ASOS MODIFICATION NOTE 7 (for Electronics Technicians)

SUBJECT : Automated Surface Observing System (ASOS) Software Version 2.0

PURPOSE : To add maintenance capability and operational enhancements for the ASOS.

FMK# 15B
ASOS FIELD MOD KIT (FMK)

FIGURE 1. ACL MEMORY BOARD EPROM LOCATIONS

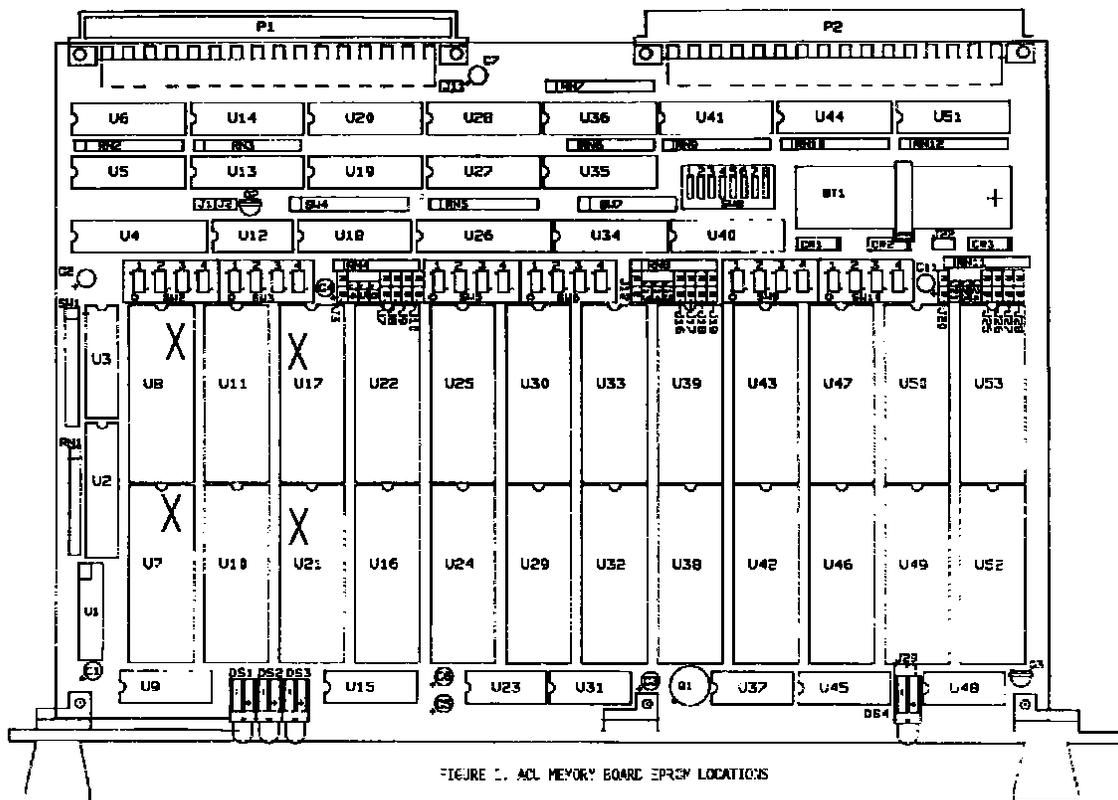
The EPROMs located on the memory board in the ACU change to Revision 2.0

All ASOS application software is contained on four erasable programmable read only memory (EPROM) integrated circuits (IC) on ACU memory board 1A2A3. Figure 1 illustrates the ACU memory board and identifies the four EPROMs (U8, U17, U7, and U21). The EPROMs are 32-pin dual in-line package (DIP) CMOS devices, each providing 512K x 8 bits of storage. Upgrading ASOS software requires only replacing the four EPROMs on the ACU memory board with higher revision level ICs.

4. Using IC insertion tool, remove new EPROM integrated circuits from protective packaging and insert into ACU memory board sockets in accordance with the following chart. Ensure that EPROMs are installed with pin 1 (as identified by notch in top of IC) oriented toward board connector P1 as shown on Figure 1.

IC socket	IC part number
U8	62828-45002-1
U17	62828-45003-1
U7	62828-45004-1
U21	62828-45005-1
